Model: Perfect Binder GB5000	Date: 20-June -08	No.: RD391001a
-------------------------------------	-------------------	----------------

Subject: Firmware Release Note: P-Binder_B1		Prepared by: T.Tadokoro	
From: PPBG QA/Service Planning Dept.			
Classification:	<input type="checkbox"/> Troubleshooting	<input type="checkbox"/> Part information	<input type="checkbox"/> Action required
	<input type="checkbox"/> Mechanical	<input type="checkbox"/> Electrical	<input type="checkbox"/> Service manual revision
	<input type="checkbox"/> Paper path	<input type="checkbox"/> Transmit/receive	<input type="checkbox"/> Retrofit information
	<input checked="" type="checkbox"/> Other ()

Subject: STAY: Parts catalog correction		Prepared by: T. Tadokoro	
From: PPBG QA/Service Planning Dept.			
Classification:	<input type="checkbox"/> Troubleshooting <input type="checkbox"/> Mechanical <input type="checkbox"/> Paper path <input type="checkbox"/> Other ()	<input checked="" type="checkbox"/> Part information <input type="checkbox"/> Electrical <input type="checkbox"/> Transmit/receive	<input type="checkbox"/> Action required <input type="checkbox"/> Service manual revision <input type="checkbox"/> Re

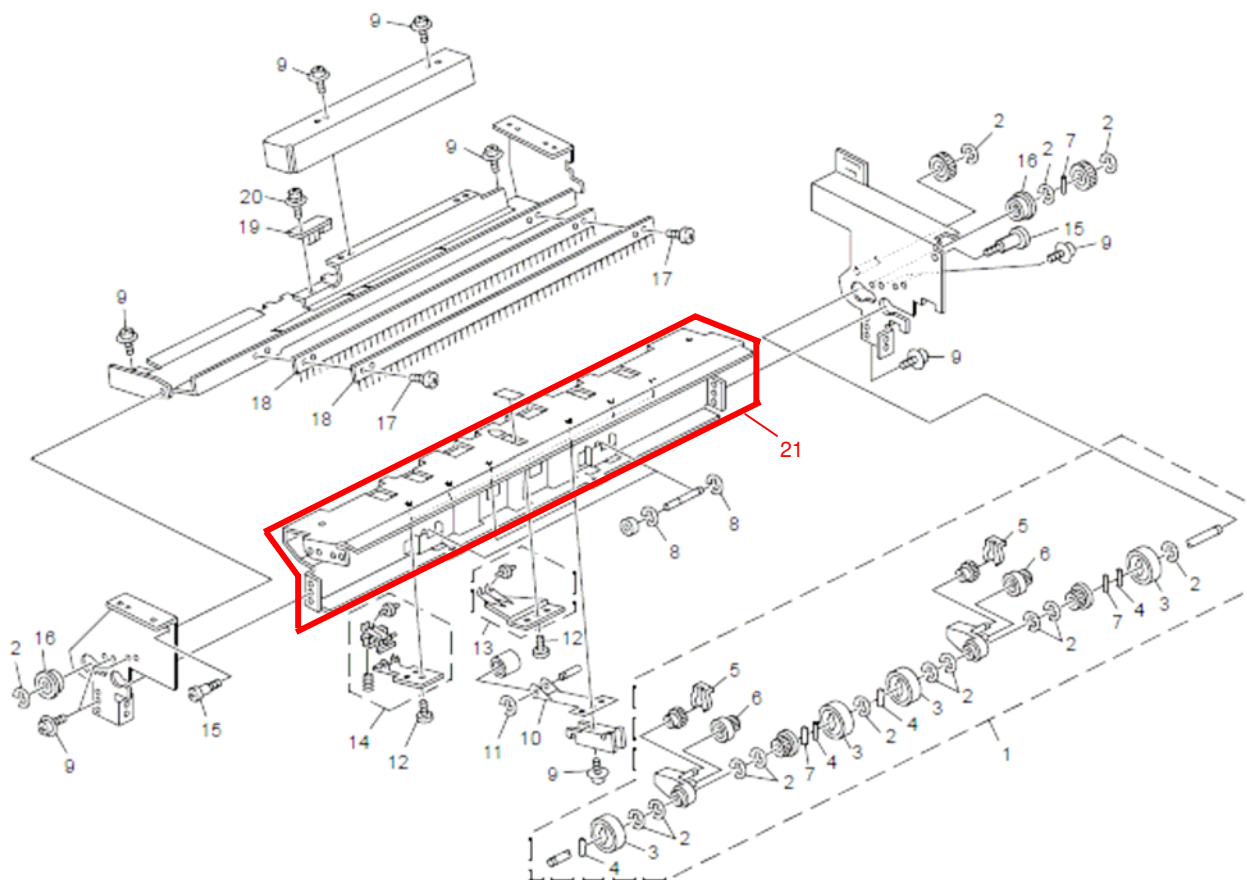
New part number	Description	Q'ty	Int	Page	Index	Note
D3911480	GUIDE PLATE:PAPER EXIT SUB-UNIT:MIDDLE:PF4140P232	1	-	58	21	Add

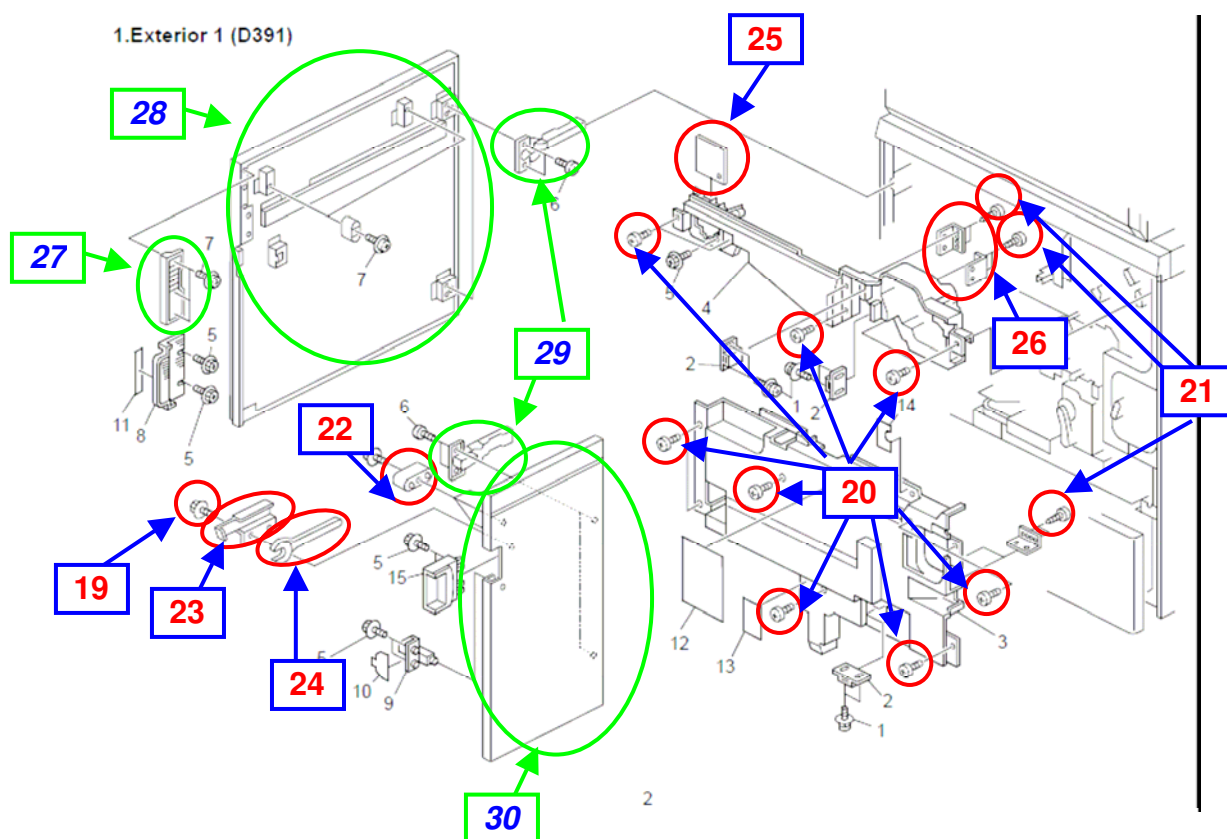
New Part Number	Description	Q'ty	Int	Page	Index	Note
D3911244	Screw:M4X8:NS-SCR00050B	1	-	2	19	Add
B6604835	Screw:NS-SCR00045A	12	-	2	20	Add
D3911117	Binding Self-Tapping Screw: M3X8: 030080FWBB	3	-	2	21	Add
D3912025	Bracket:Pick-up Paper Jam: Door: PF4140Q543	1	-	2	22	Add
D3912026	Holder:Wrench:PF4140P010	1	-	2	23	Add
D3912027	Wrench:19MM:PF4140P900	1	-	2	24	Add
D3912029	Inner Cover:Base:PF4140Q511	1	-	2	25	Add
D3912030	Plate:Magnetic:Door:PF4140Q510	2	-	2	26	Add
<i>D3912022</i>	<i>COVER:DOOR:LEFT:PF4155Q555</i>	<i>1</i>	<i>-</i>	<i>2</i>	<i>27</i>	<i>Add</i>
<i>D3912023</i>	<i>DOOR:FRONT LEFT:PF4155Q500</i>	<i>1</i>	<i>-</i>	<i>2</i>	<i>28</i>	<i>Add</i>
<i>D3912024</i>	<i>ARM:HINGE:DOOR:PF4140P920</i>	<i>2</i>	<i>-</i>	<i>2</i>	<i>29</i>	<i>Add</i>
<i>D3912028</i>	<i>DOOR:FRONT RIGHT:PF4155Q501</i>	<i>1</i>	<i>-</i>	<i>2</i>	<i>30</i>	<i>Add</i>

Part Number	Incorrect Description	Correct Description	Q'ty	Int	Page	Index
D3912007	Handle:Door:Left: PF4140Q529B1	Handle:Door:Left:PF4155Q529	1	-	2	8

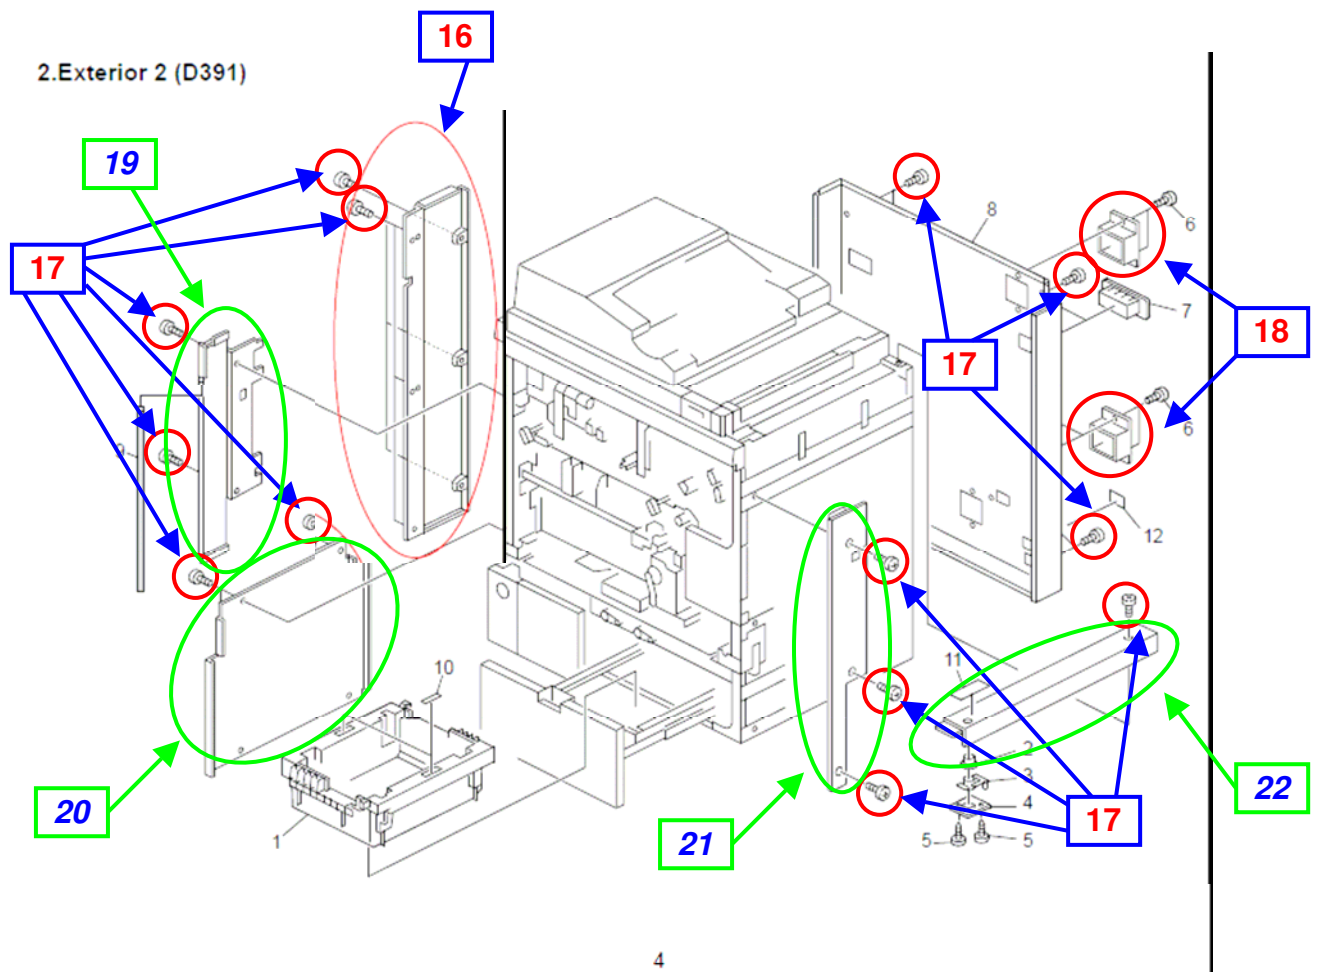
New Part Number	Description	Q'ty	Int	Page	Index	Note
D3914500	Cover:Left Rear:PF4165Q525	1	-	4	16	Add
B6604835	Screw:NS-SCR00045A	20	-	4	17	Add
D3912034	Cover:Fan:PF4155K102	2	-	4	18	Add
D3912031	COVER:LEFT:PF4155Q522	1	-	4	19	Add
D3912032	COVER:LEFT LOWER:PF4155Q513	1	-	4	20	Add
D3912033	COVER:RIGHT:PF4155Q506	1	-	4	21	Add
D3912035	COVER:MAIN SWITCH:PF4155Q537	1	-	4	22	Add

Part Number	Incorrect Description	Correct Description	Q'ty	Int	Page	Index
D3911269	Case:Paper Chip: PF4140K376A:Ass'y	Case:Paper Chip: PF4155K376:Ass'y	1	-	4	1
D3912018	Keytop:PF4140Q544A5	Keytop:PF4155Q544	1	-	4	2
D3912002	Grip:Rear:PF4140P931A	Grip:Rear:PF4155K106	2	-	4	7
D3912005	Cover:Rear:PF4140Q508L	Cover:Rear:PF4155Q508	1	-	4	8

3.Exterior 3 (D391)

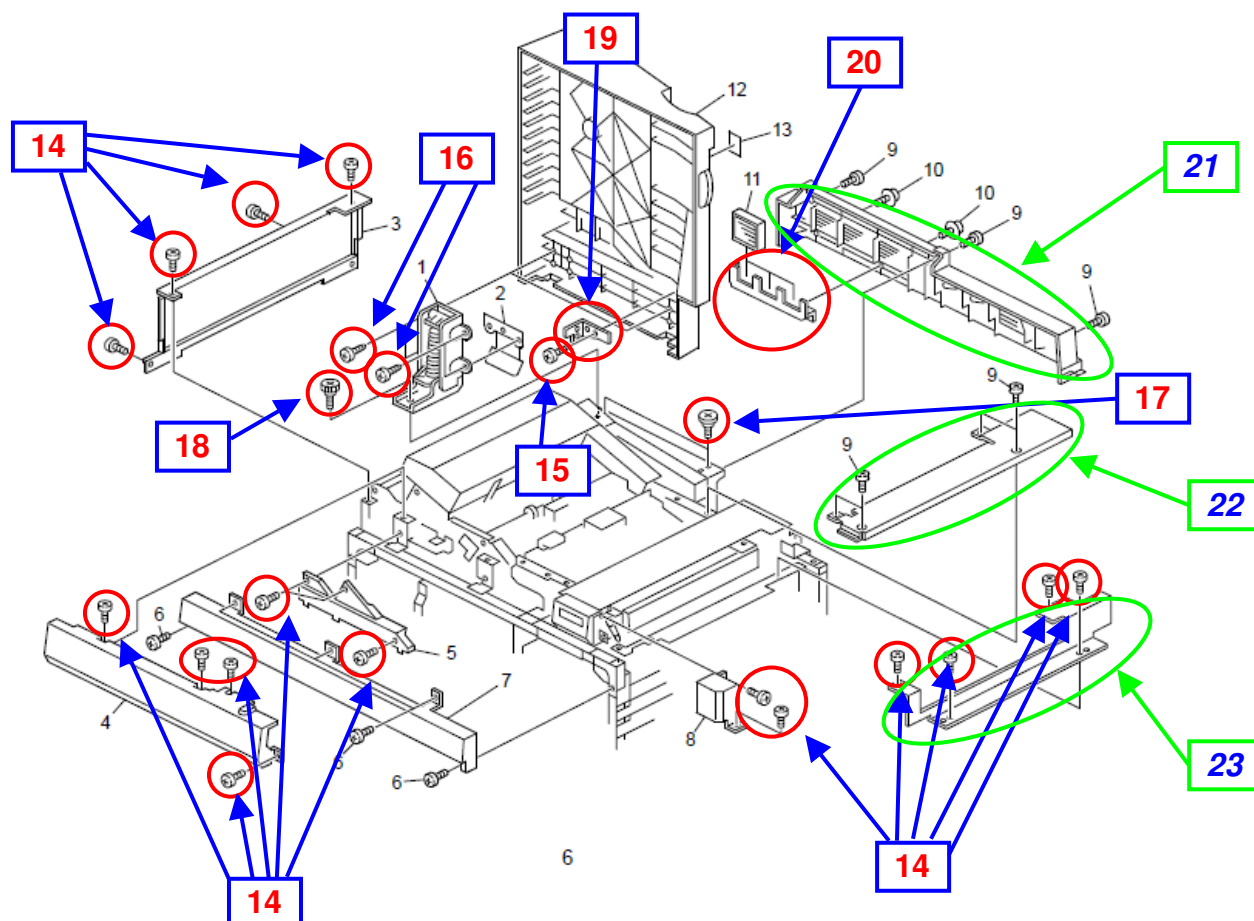
New Part Number	Description	Q'ty	Int	Page	Index	Note
B6604835	Screw:NS-SCR00045A	16	-	6	14	Add
D3911117	Binding Self-Tapping Screw: M3X8: 030080FWBB	1	-	6	15	Add
D3911131	Binding Self-Tapping Screw: M4X10: 040100FWBB	4	-	6	16	Add
D3914111	Screw:PF3091P352	2	-	6	17	Add
D3914112	Screw:PF3091P356	1	-	6	18	Add
D3912036	Feeler:Sensor:PF4140Q523	1	-	6	19	Add
D3912037	Bracket:Holder:Filter:PF4140Q559	1	-	6	20	Add
D3912038	COVER:REAR UPPER:PF4155Q534	1	-	6	21	Add
D3912039	COVER:UPPER MIDDLE:PF4155Q509	1	-	6	22	Add
D3912040	COVER:RIGHT UPPER:PF3099P808	1	-	6	23	Add

Part Number	Incorrect Description	Correct Description	Q'ty	Int	Page	Index
D3912004	Cover:Left Upper: PF4140Q507E	Cover:Left:Upper: PF4155Q507	1	-	6	3
D3912015	Cover:Left Front:Upper: PF4140Q538C1	Cover:Left Front: Upper: PF4155Q538	1	-	6	4
D3912003	Cover:Front Upper: PF4140Q505C	Cover:Front Upper: PF4155Q505	1	-	6	7
D3912014	Cover:Right Front:Upper: PF4140Q536B1	Cover:Right Front:Upper: PF4155Q536	1	-	6	8
D3912011	Cover:Upper:Open/Close: PF4140Q533C1	Cover:Upper:Open/Close: PF4155Q533	1	-	6	12

4.Transit Pass Unit 1 (D391)

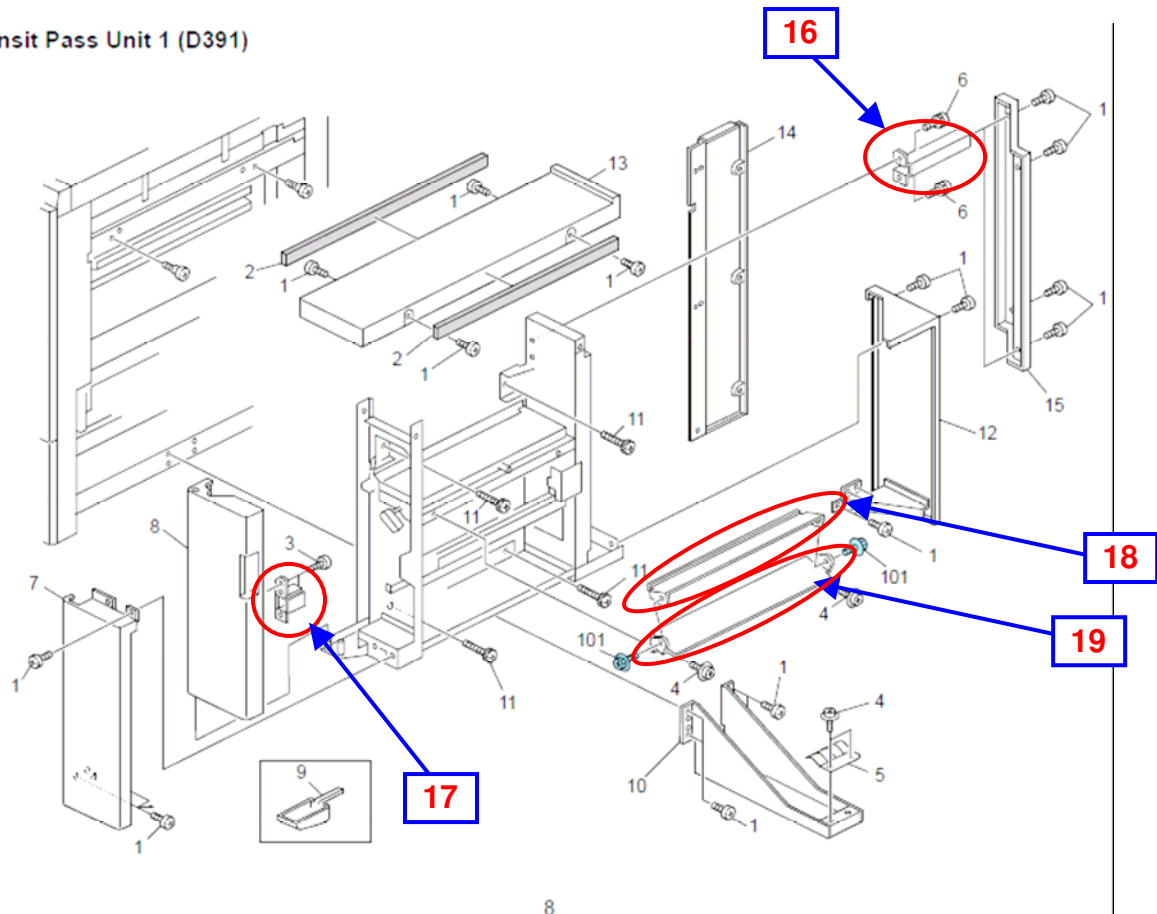
New Part Number	Description	Q'ty	Int	Page	Index	Note
D3914513	Bracket:Cover:Rear:PF4165Q625	1	-	8	16	Add
D3914514	Bracket:Magnet Catch:PF4165Q626	1	-	8	17	Add
B6601768	Guide Plate:Connecting:PF4147P818A	1	-	8	18	Add
B8307511	Guide Plate:Connecting:Lower	1	-	8	19	Add

5.Transit Pass Unit 2 (D391)

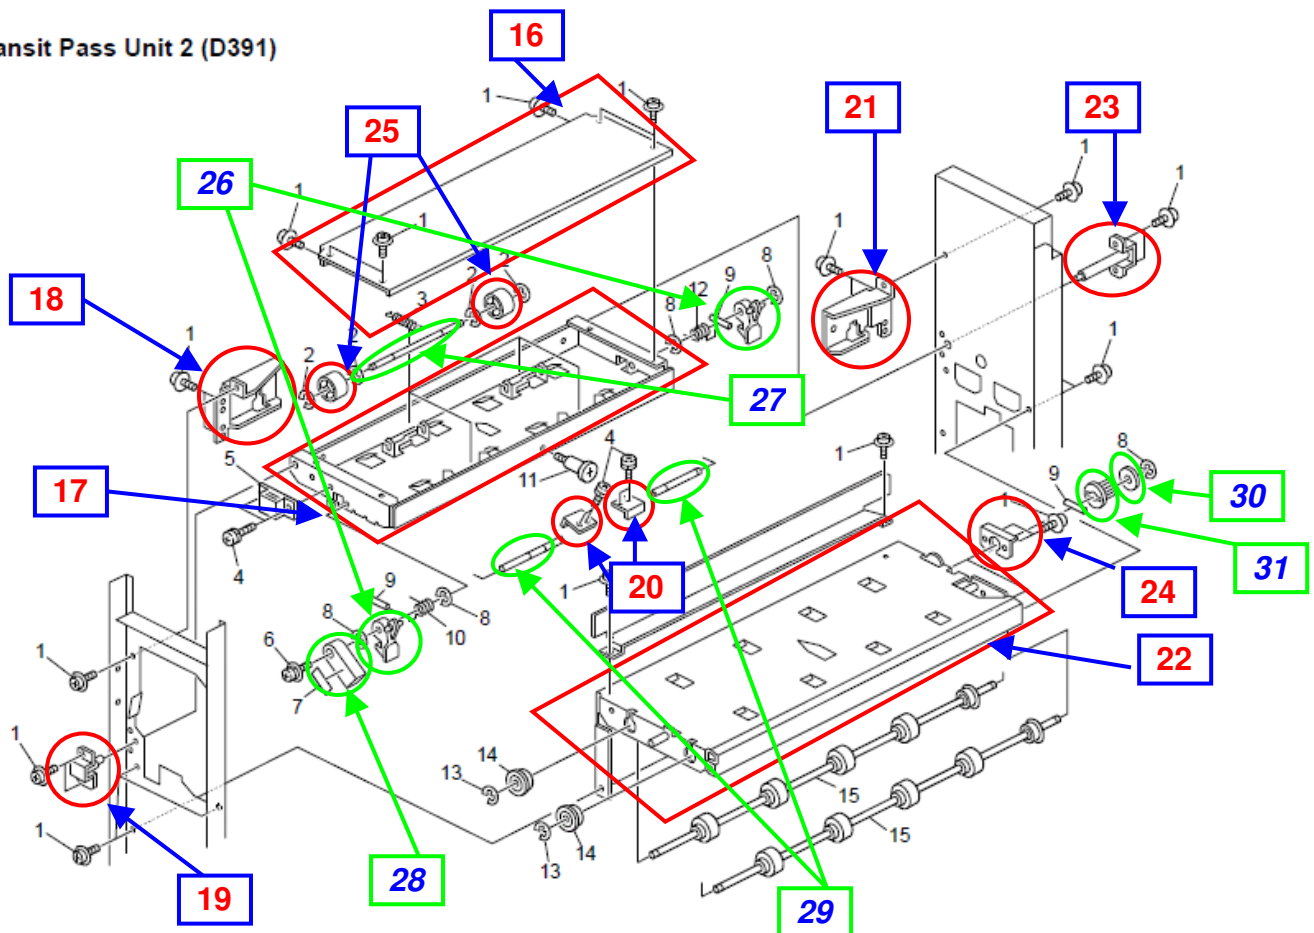
New Part Number	Description	Q'ty	Int	Page	Index	Note
D3914515	Cover:Upper:PF4165Q618	1	-	10	16	Add
D3914516	Stay:Transport:Upper:PF4165Q604	1	-	10	17	Add
D3914517	Bracket:Transport:Front:PF4165Q607	1	-	10	18	Add
D3914526	Shaft:Transport Sub-Unit: Front: PF4165K604	1	-	10	19	Add
D3914529	Plate:Release:PF4140P637	2	-	10	20	Add
D3914531	Bracket:Transport:Rear:PF4165Q608	1	-	10	21	Add
D3914532	Stay:Transport:Lower:PF4165Q606	1	-	10	22	Add
D3914533	Shaft:Transport Sub-Unit: Rear:PF4165K605	1	-	10	23	Add
D3914536	Bracket:Shaft:Transport Roller: PF4165Q609	1	-	10	24	Add
D3911350	Collar:PF4140P958A	2	-	10	25	Add
D3914528	BRACKET:RELEASE:PF4140P120	2	-	10	26	Add
D3914518	SHAFT:ROLLER:PF4140P618	1	-	10	27	Add
D3914519	HOLDER:SHAFT:RELEASE:PF4155P607	2	-	10	28	Add
D3914530	SHAFT:RELEASE:PF4165Q651	1	-	10	29	Add
D3914535	FLANGE:TIMING PULLEY:PF4099P225	1	-	10	30	Add
D3914534	TIMING PULLEY:S2MX16:PF4140P631	1	-	10	31	Add

6.Transit Pass Unit 3 (D391)

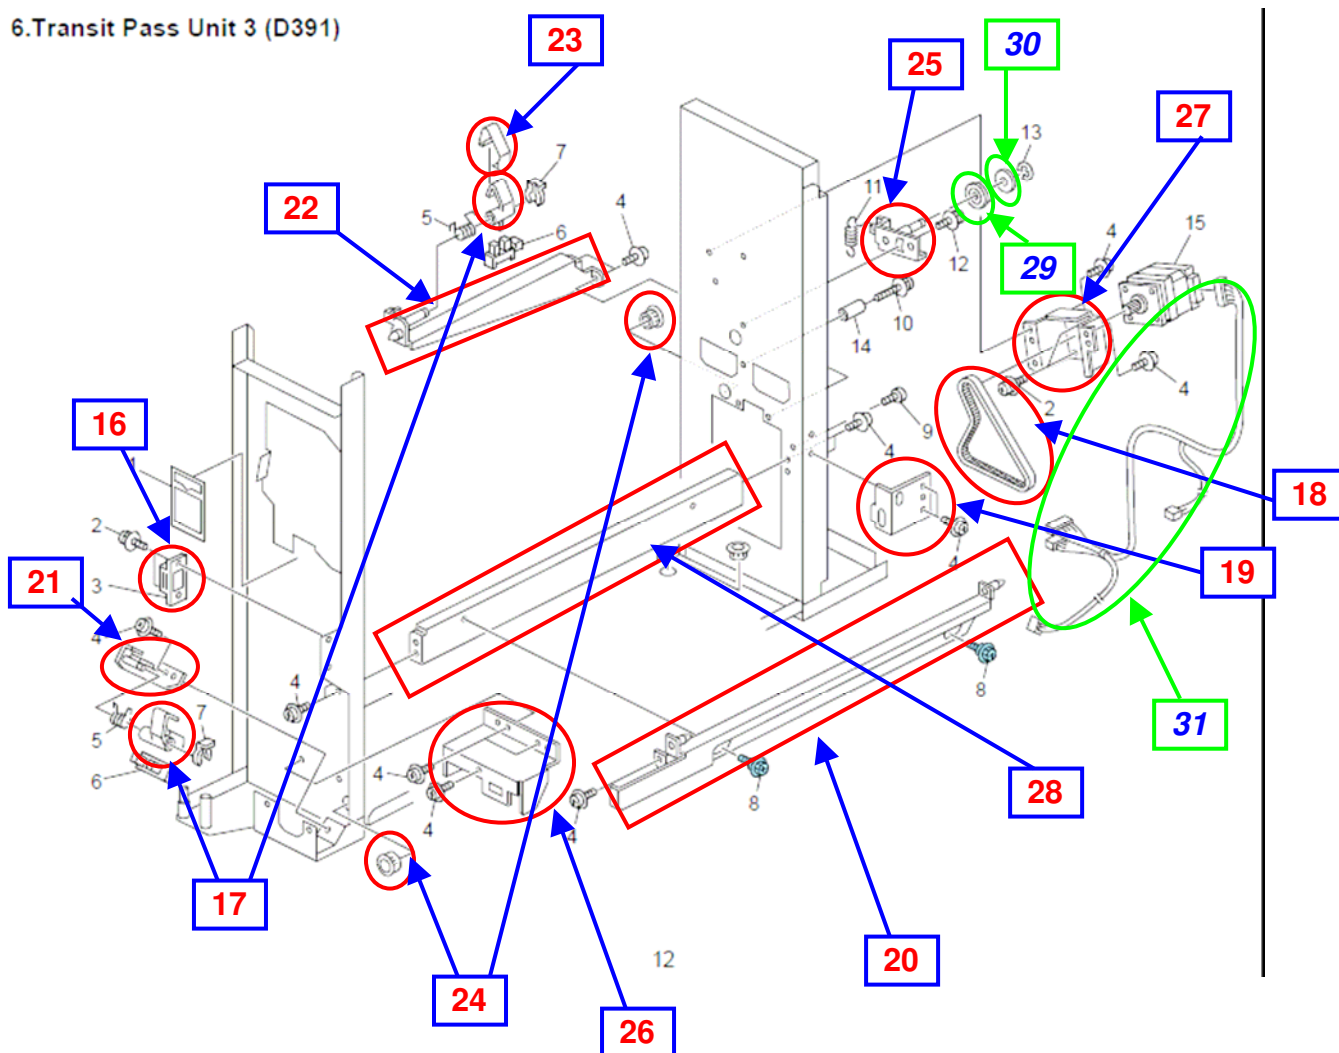
New Part Number	Description	Q'ty	Int	Page	Index	Note
B6601111	Magnet Catch:13N:PF2214P393A	1	-	12	16	Add
D3911328	Lever:Sensor:PF4140P614B2	2	-	12	17	Add
D3914525	Synchronous Belt:NS-BLT00452A	1	-	12	18	Add
B6601436	Bracket:Ground Plate:PF4147P139A	1	-	12	19	Add
B6601212	Lever:Coupling:PF4147P197A	1	-	12	20	Add
D3914537	Bracket:Sensor:PF4140K059:PEEN	1	-	12	21	Add
D3914538	Bracket:Sensor:Release:PF4165K608	1	-	12	22	Add
D3914539	Spring Plate: Sensor: Release: PF4140P714	1	-	12	23	Add
D3914540	Timing Pulley:E450001234	2	-	12	24	Add
D3914541	Bracket:Tightener:PF4165K606	1	-	12	25	Add
D3914542	Cover:Sensor:Release:PF4165Q619	1	-	12	26	Add
D3914545	Bracket:Dc Stepper Motor: PF4140P629	1	-	12	27	Add
D3914547	Stay:Right:PF4165Q603	1	-	12	28	Add
D3914543	ROLLER:SYNCHRONOUS BELT: PR5100P216	1	-	12	29	Add
D3914544	FLANGE:ROLLER:PF4099P950	1	-	12	30	Add
D3914546	HARNESS:JOINT UNIT:PF4165K906	1	-	12	31	Add

7.Inserter Section 1 (D391)

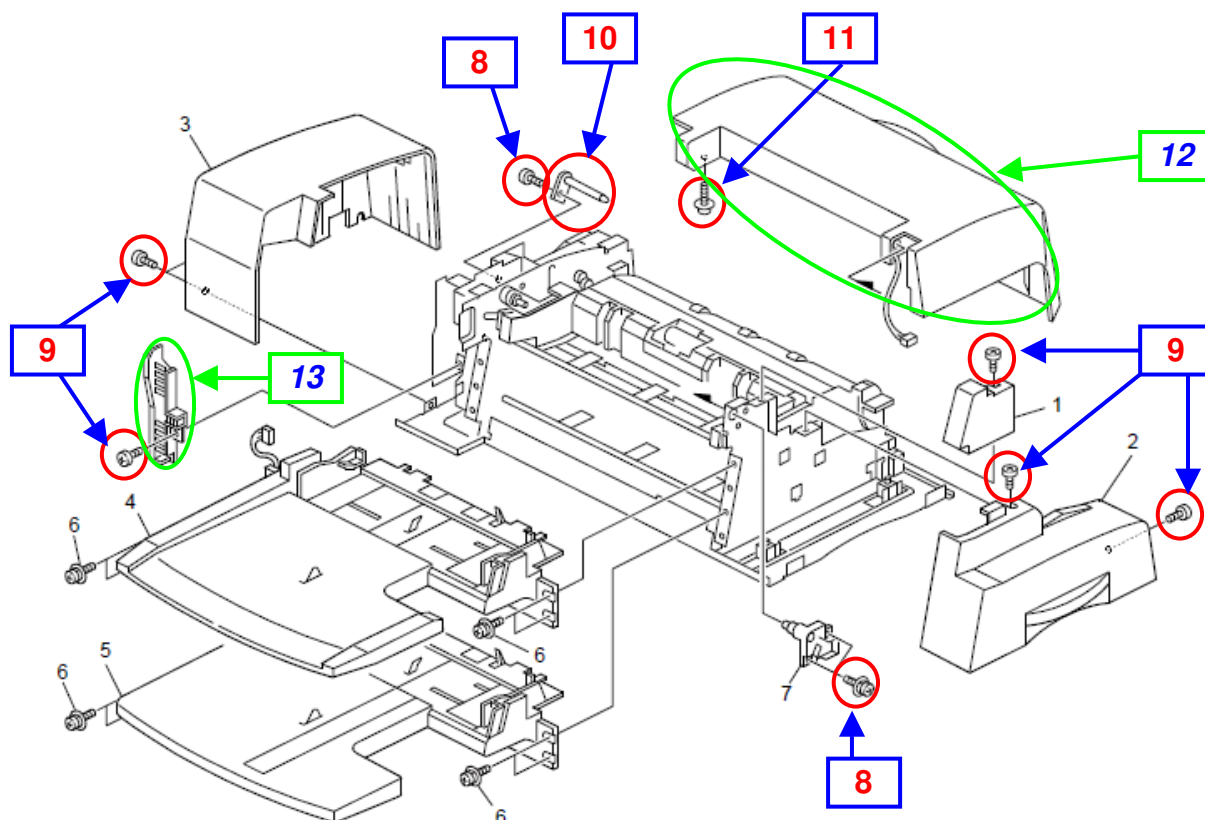
New Part Number	Description	Q'ty	Int	Page	Index	Note
D3911116	Screw With Washer: M3X6:030060FWWS	3	-	14	8	Add
B6604835	Screw: NS-SCR00045A	5	-	14	9	Add
D3914114	Stopper:Open And Close: Cover: PF3091K015:PEEN	1	-	14	10	Add
D3914116	Tapping Screw:M3X8:030080FWTP	1	-	14	11	Add
D3914115	COVER:UPPER:PF3099P004	1	-	14	12	Add
D3914113	DUCT:UPPER:PF3091P095	1	-	14	13	Add

Part Number	Incorrect Description	Correct Description	Q'ty	Int	Page	Index
D3914030	Cover:Front:Sub:PF3091P002A	Cover:Front:Sub:PF3099P002	1	-	14	1
D3914029	Cover:Front:PF3091P001A	Cover:Front:PF3099P001	1	-	14	2
D3914031	Cover:Rear:PF3091P003A	Cover:Rear:PF3099P003	1	-	14	3
D3914026	Tray Unit: Upper: PF3091K152A:Ass'y	Tray Unit: Upper: PF3099K152:Ass'y	1	-	14	4
D3914025	Tray Unit: Lower: PF3091K144A:Ass'y	Tray Unit: Lower: PF3099K144:Ass'y	1	-	14	5
